THE GARDENS AT NORTH CAREFREE CONSTRUCTION DRAWINGS EL PASO COUNTY, STATE OF COLORADO

| GARDENS AT NORTH CAREFREE TITLE SHEET | |

**THE GARDENS AT NORTH CAREFREE
 PLAN AND PROFILE
 KNUCKLES**

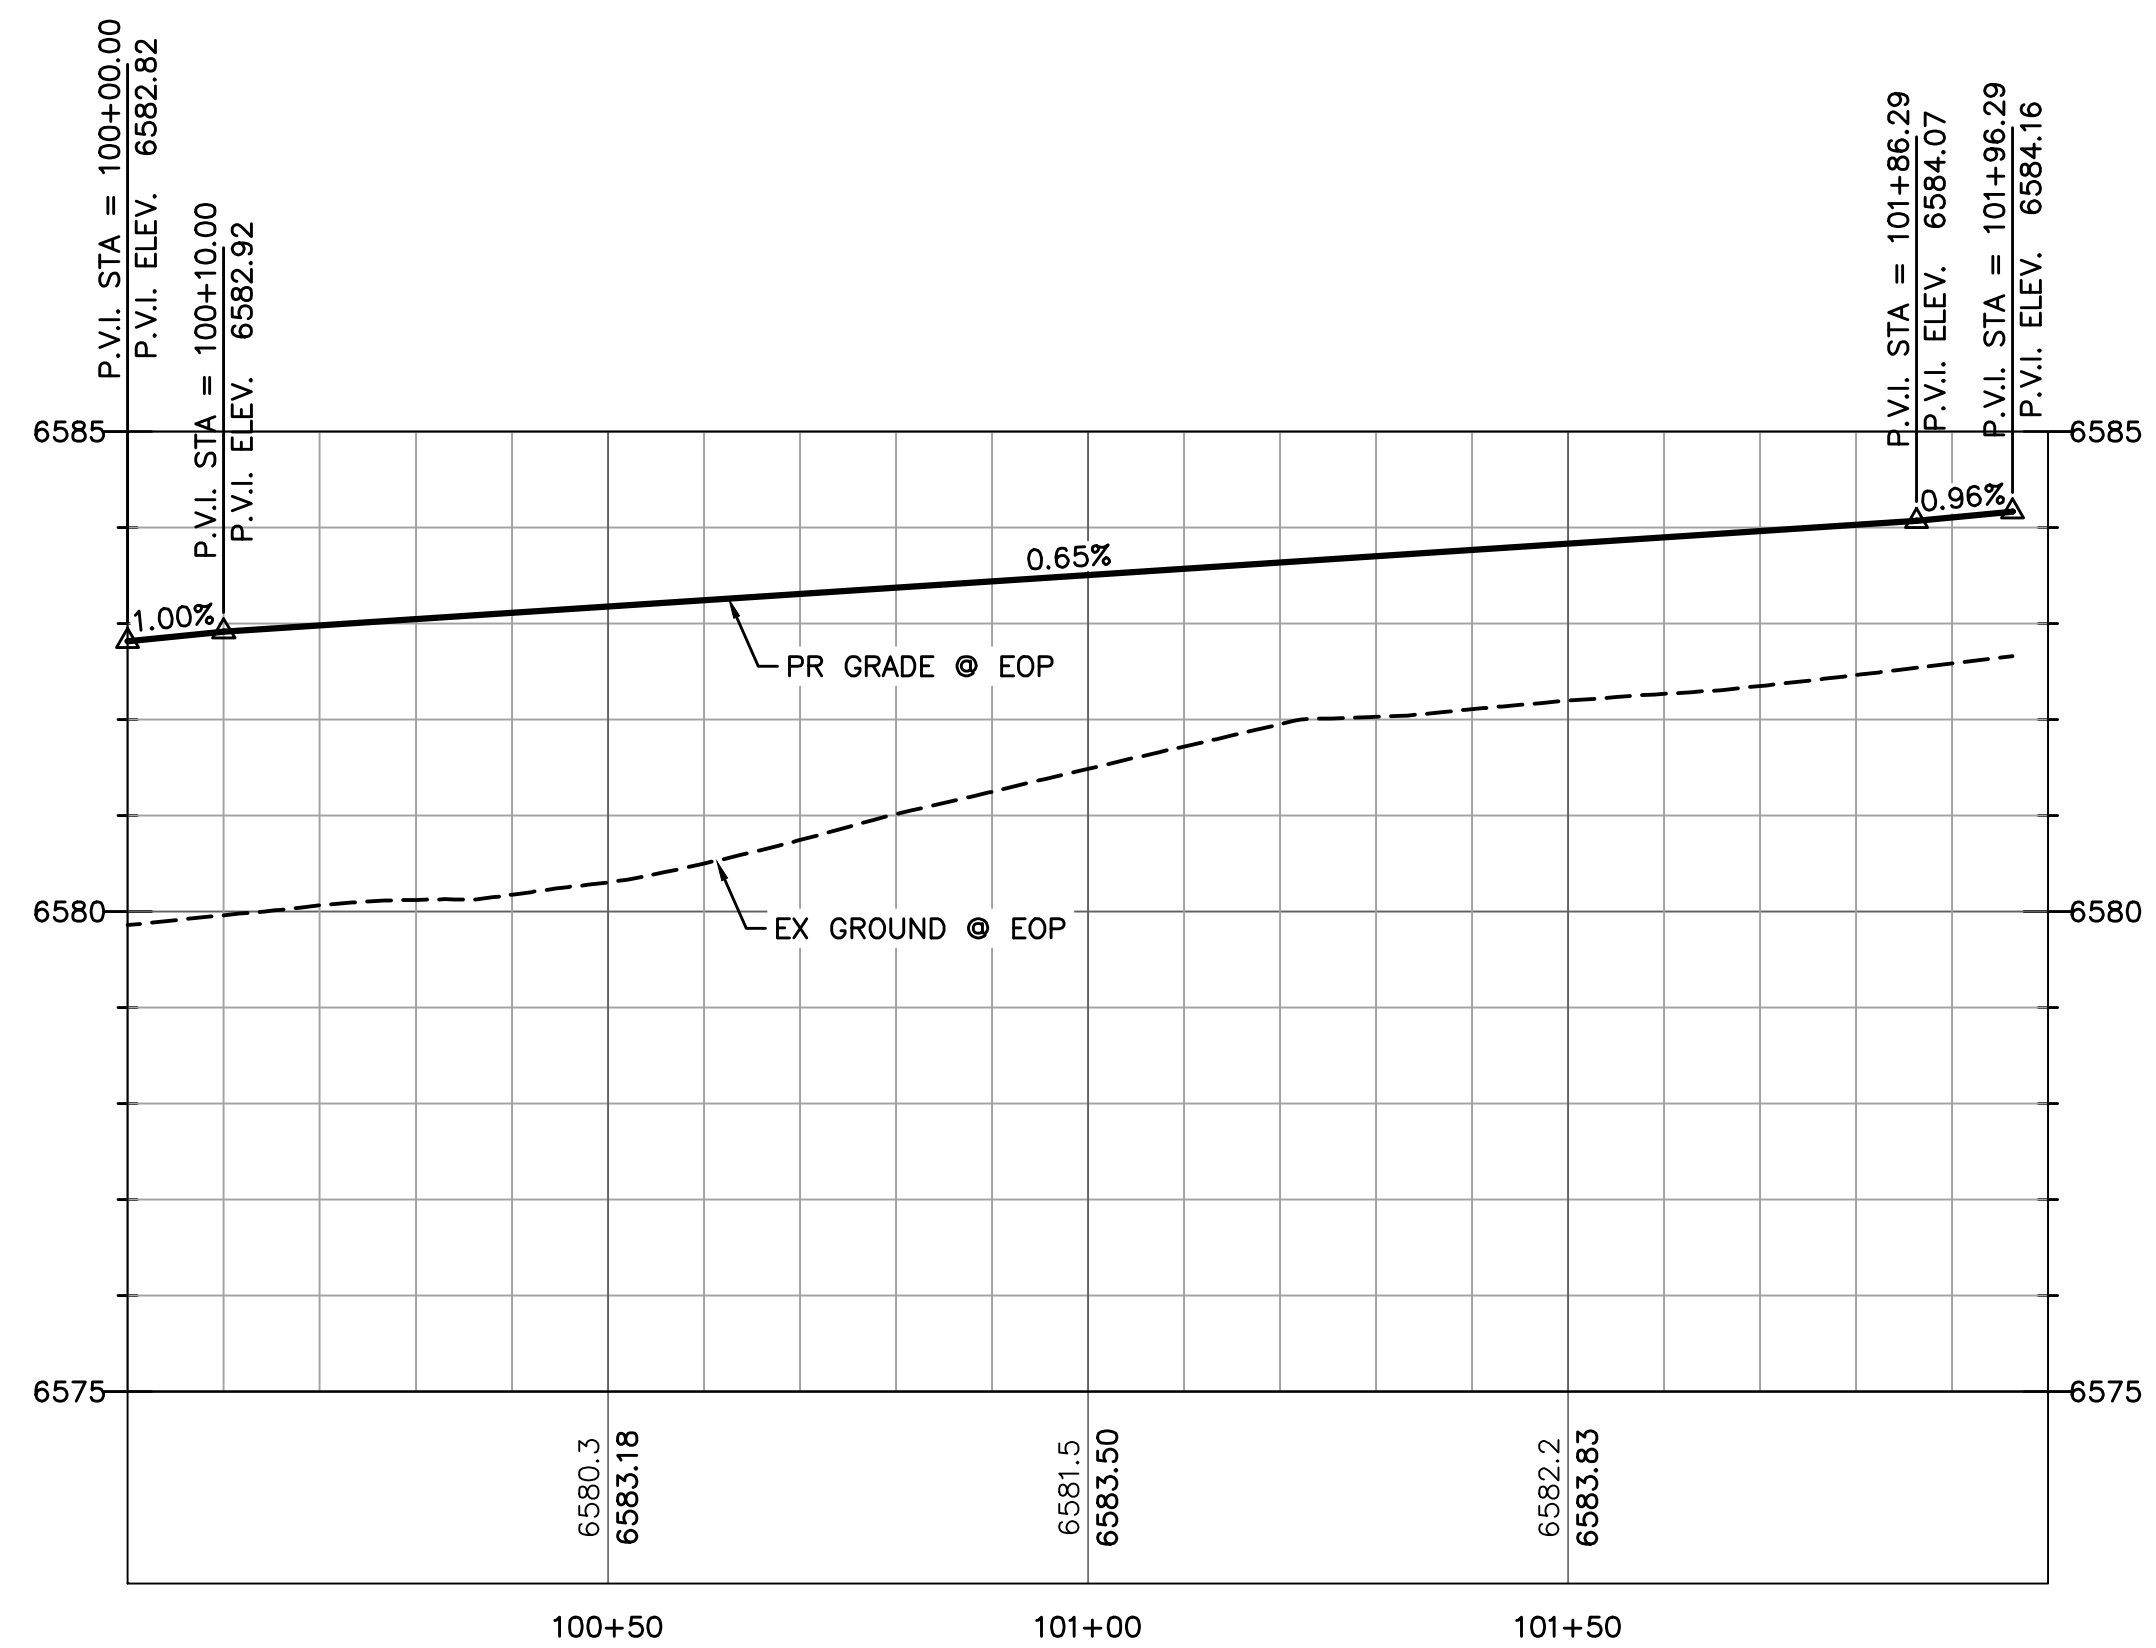
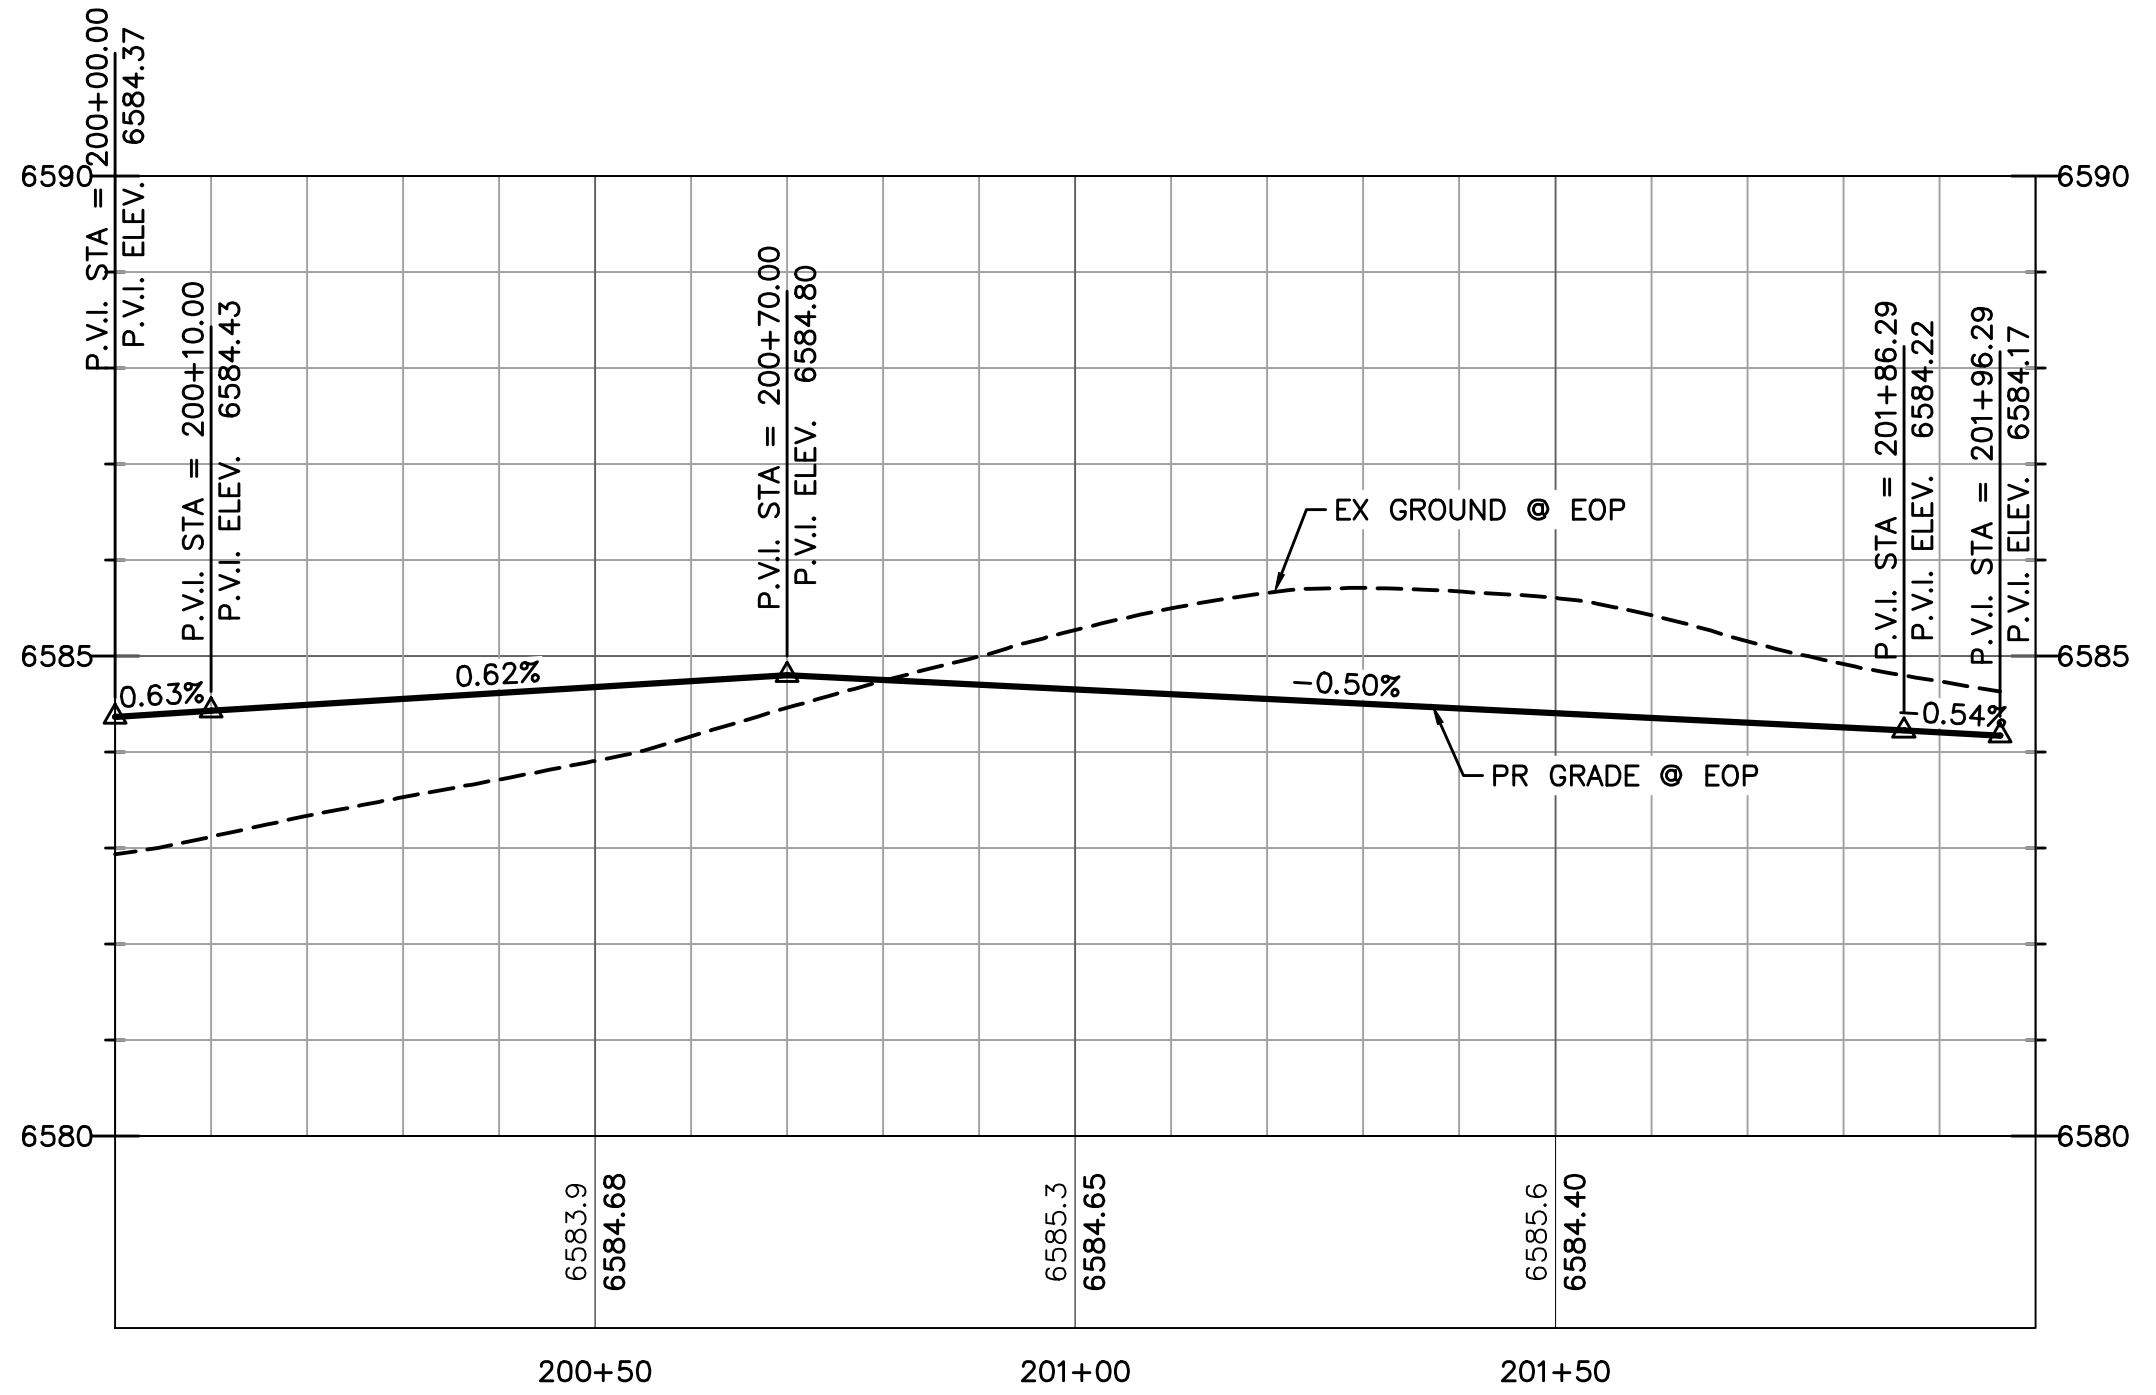
Please provide slope tags on this knuckle also.
